SOLICITATION AMENDMENT MODIFICATION DE L'INVITATION

Title - Sujet CCGS Griffon dry dock refit	
Solicitation No. - N° de l'invitation F2599-155003/A	Amendment No. - N° modif. 001
Client Reference No. - N° de référence du client F2599-155003	Date 2015-06-22
GETS Reference No. - N° de référence de SEAG PW-\$\$\$MD-030-25144	
File No. - N° de dossier 030md.F2599-155003	CCC No./N° CCC - FMS No./N° VME
Solicitation Closes - L'invitation prend fin at - à 02:00 PM on - le 2015-06-26	Time Zone Fuseau horaire Eastern Daylight Saving Time EDT
F.O.B. - F.A.B. Plant-Usine: <input type="checkbox"/> Destination: <input type="checkbox"/> Other-Autre: <input type="checkbox"/>	
Address Enquiries to: - Adresser toutes questions à: Cook, Kristin	Buyer Id - Id de l'acheteur 030md
Telephone No. - N° de téléphone (819) 956-1397 ()	FAX No. - N° de FAX () -
Destination - of Goods, Services, and Construction: Destination - des biens, services et construction:

BIDDER'S CONFERENCE MINUTES

SPEC 789.14 AMENDMENT 1

SECTION 25.0 - PHOTOGRAPHS

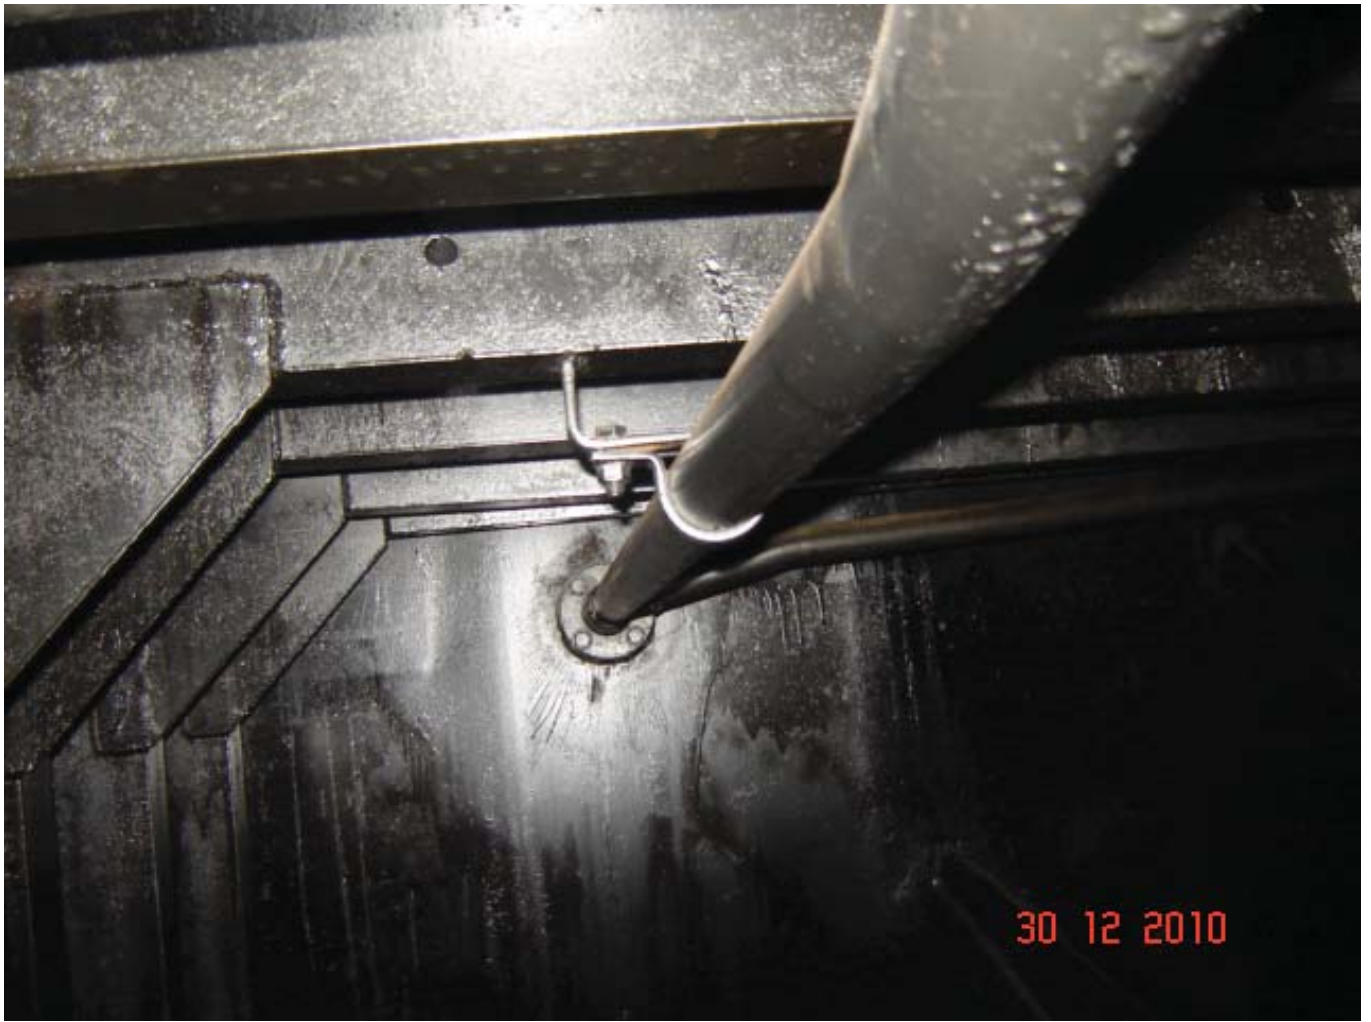
Request to provide visual representation for this section, as access is restricted. CA to provide via amendment. Any photos provided are intended to be for information only and cannot be considered as information for pricing purposes.

25.3.7 Pictures of VOID space
